NONCONFORMANCE REPORT

LIMERICK GENERATING STATION UNITS 1 & 2
 PHILADELPHIA ELECTRIC COMPANY

REACTOR BUILDING UNIT
 STRUCTURAL STEEL
 FRAMING PLAN ELEV. 217

THIS NCR IS WRITTEN IN RESPONSE TO P.E. Co. AUDIT FINDING # N-093. THE CORRECTIVE ACTION INCLUDED RE-INSPECTION OF A NUMBER OF WELDS, HOWEVER SOME OF THESE WERE FOUND TO BE PERMANENTLY INACCESSIBLE, FOR VARIOUS REASONS, AND ARE DOCUMENTED IN THIS NCR.

TYPICAL BEAMS TO COL. WEBS.

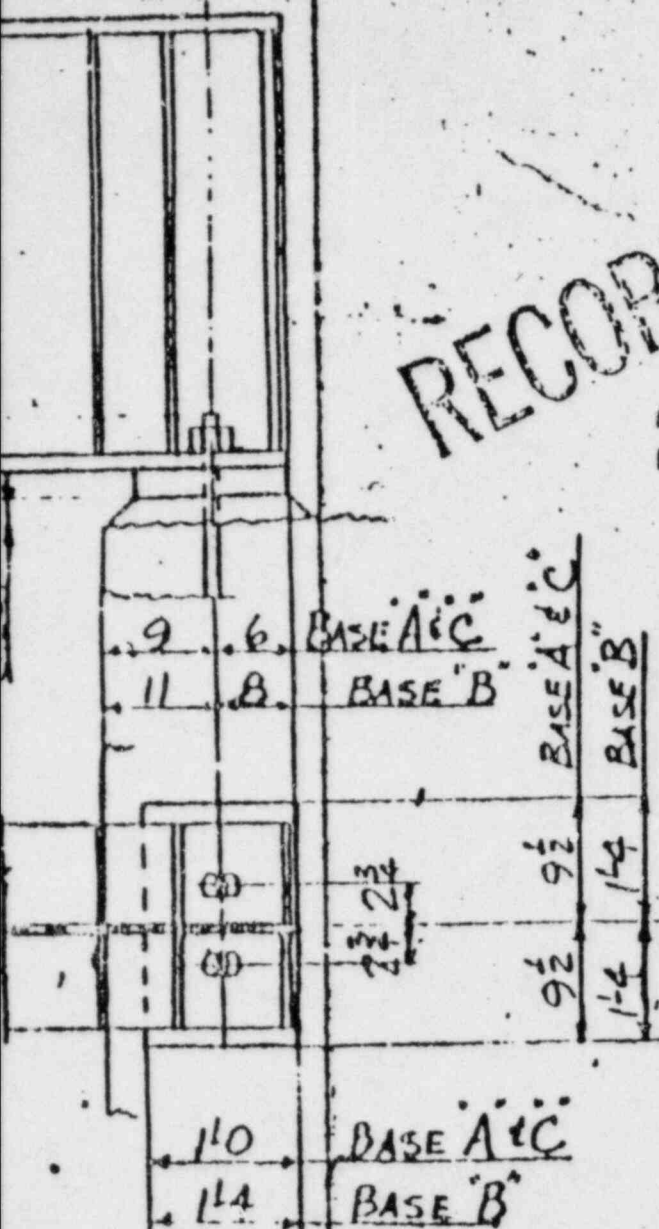
4. ITEM INSPECTED Re-inspection of walls in question in Quality Control inspection plan C-41A-116-W-1-1. Angles to columns fillet welds beam 120B8 left hand end along side to column 103C2 beam 120B8 right hand end along side to column 105C1 beam 120B1 right hand end along side to column 105C2 beam 127B7 right hand end along side to column 103C1 - 13" only remainder in concrete beam 134B7 left hand end along side to column 103C1 - 9" only on both sides remainder in concrete beam 119B11 right hand end along side to column 10417 - 14 1/2" only on left side remainder in concrete, (cont)

ITEM 1: RADWASTE BLDG. STR. STEEL ELEV. 191'-0 (Dwg C-543 AND VENDOR PRINT 8031-C41A-116-4, K5944 E3)

13 CLIP ANGLE CONNECTION WELDS WERE INSPECTED, 7 WERE FULLY ACCEPTIBLE, 6 HAD THE UPPER PART OF THE ANGLE EMBEDDED IN SLAB CONCRETE (WITH THE LOWER PORTION ACCEPTIBLE) THE SIX LOCATIONS ARE DESCRIBED ON SHEETS 5 AND 11 OF THIS NCR.

- (1) RADWASTE BLDG. STR. STEEL, ELEV. 191'-0"
BEAMS 127B7, 127B11, 134B2 AND 119B11.
USE AS IS

RATIONALE: PER ENGINEERING ANALYSIS, FILE 41-P,
SHEET NOS. 131 TO 136, VISIBLE WELD IS 'CAPABLE'
OF SUPPORTING DESIGN LOAD.

FIGURE 7

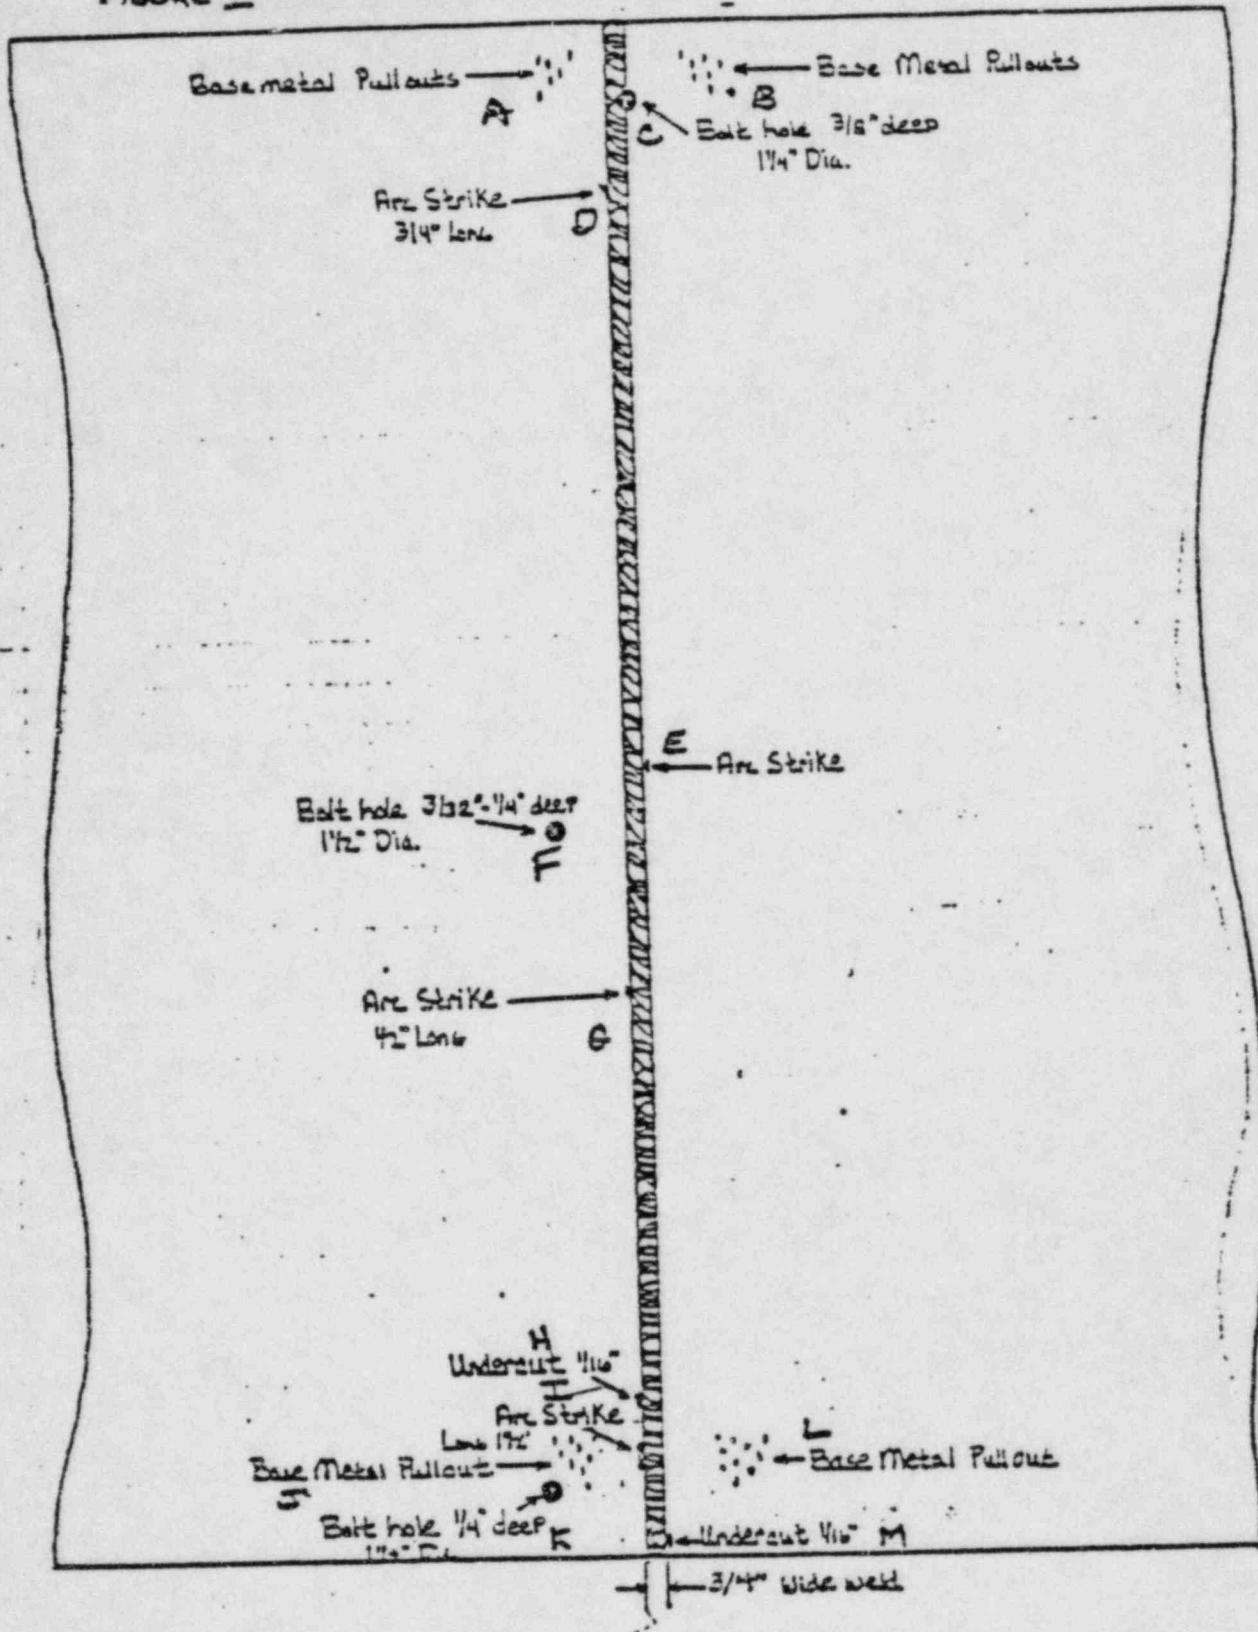
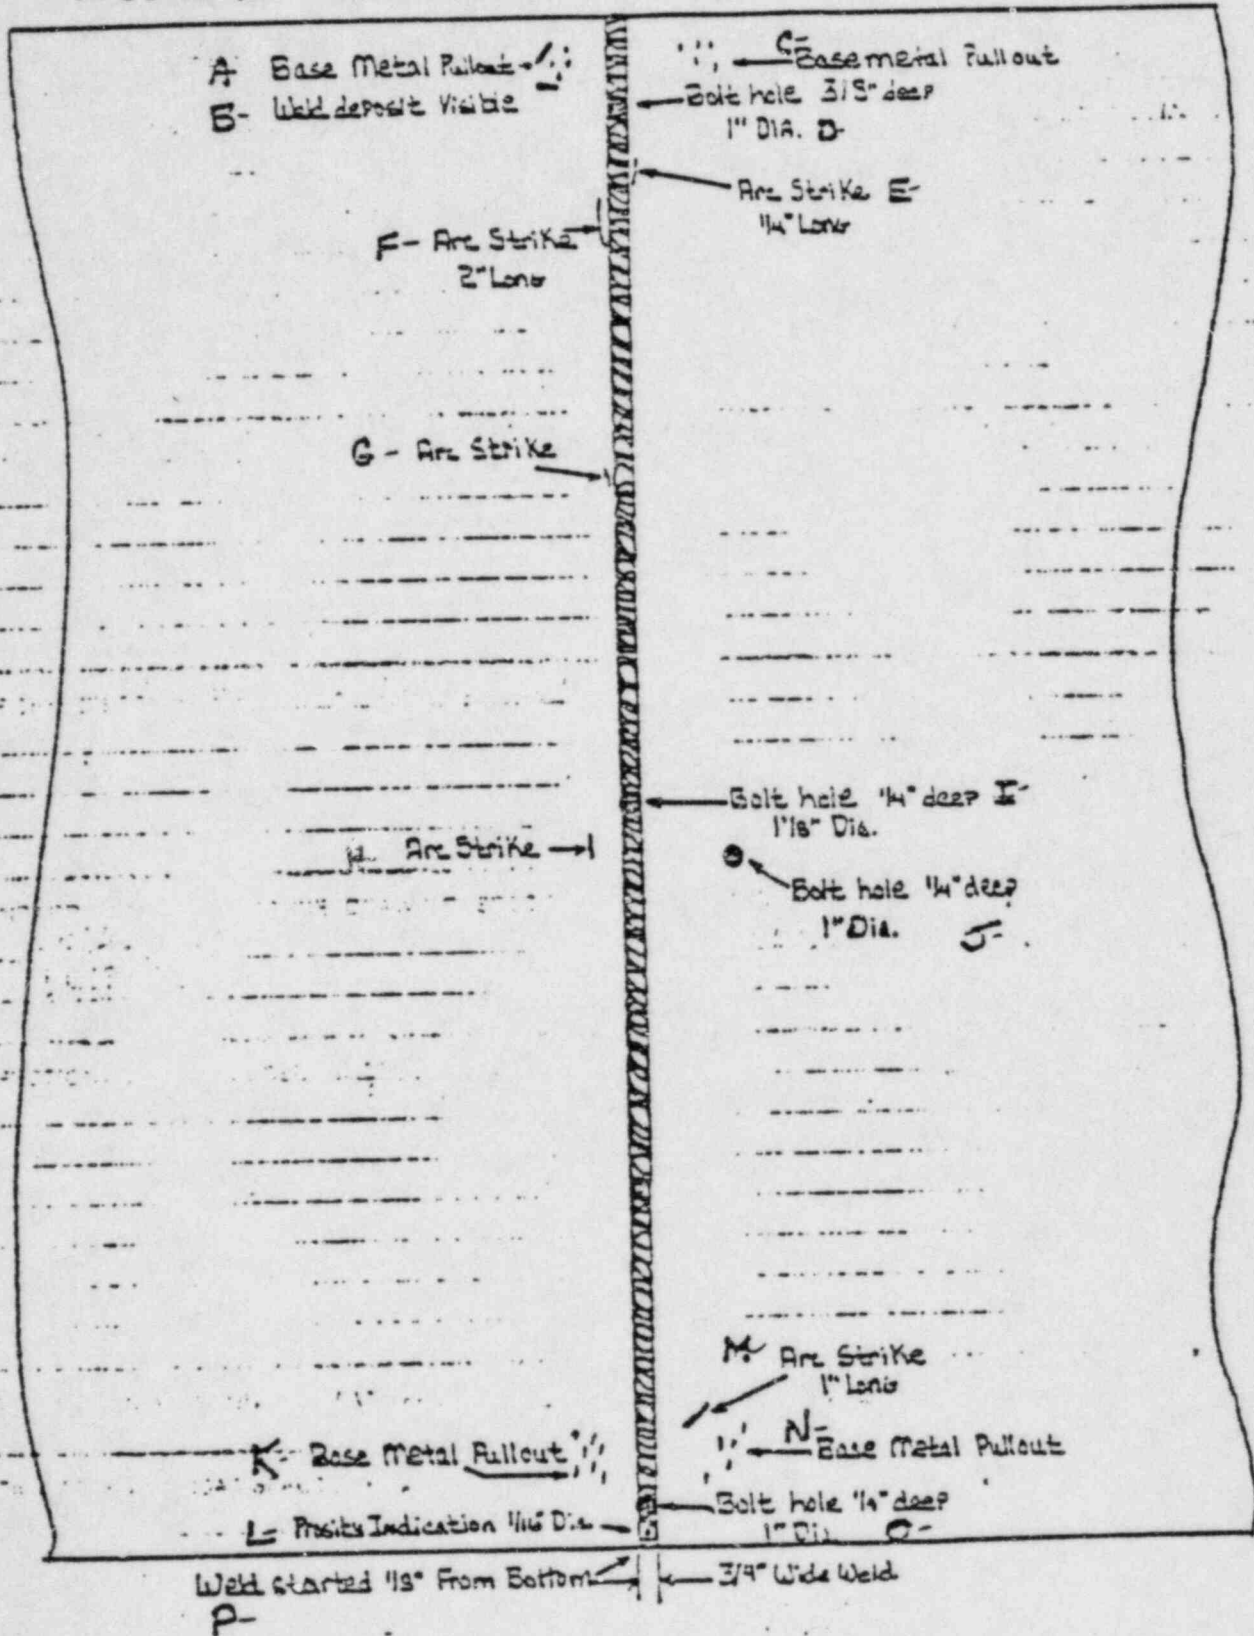
It is indicated by the attached Field Inspection Report page 14 and 15 of 24 pages & referenced in Block 19 of the QC-61-1 Control No. C954-6 is submitted for Project Engineering evaluation. Please find listed below an identification of the defects, their description, the cause of hardening, the metal pullout only one (1) the first three items is recorded any others related to the immediate area are of less magnitude. This work was done by Special Field Area in support of Specification 8031-C-69 OER housing support, angled plate, fabrication. The field measurements that these surface dimensions determine if the work is acceptable or not is to be recorded in the report.

Undercut. Washout at top of weld

ITEM 5: RPV PEDESTAL UNIT 2 CRD HOUSING SUPPORT EMBED PLATE (DWG C954)

AT SPICE LOCATIONS (90° AND 270°), EMBED PLATE HAS A NUMBER OF DEFICIENCIES DESCRIBED ON SHEETS 3, 4, 14, 15, AND 16 OF THIS NCR. NO BACKING BAR WAS USED FOR THE SPICE WELDS (AS DETERMINED FROM THE TOP OF THE PEDESTAL CONSTR. J-1) AND THE BACK SIDE OF THE PLATE IS INACCESSIBLE FOR INSPECTION.

5) RPV PEDESTAL, UNIT 2, CRD HOUSING SUPPORT EMBED PLATE (DWG. C-954 & G.E. DWG. 761 & 724 SHTS 1 & 2)

(9) DEFICIENCIES DESCRIBED ON SHEETS 3, 4, 14, 15 & 16, BASED ON ENGINEERING EVALUATIONS, THESE KINDS

(5) CONT'D. OF IMPERFECTIONS WILL NOT AFFECT THE STRUCTURAL INTEGRITY OF THE 3/4" THICK PLATES.

(b) BACKING BAR NOT USED FOR SPLICE WELDS
SPLICE WELDS WERE NOT DESIGNED & NOT REQUIRE FOR STRUCTURAL SUPPORTS. SPLICE WELDS WERE PROVIDED AT LOCATIONS 90° & 270° TO FORM A CONTINUOUS BACKING FOR CONCRETE POUR.
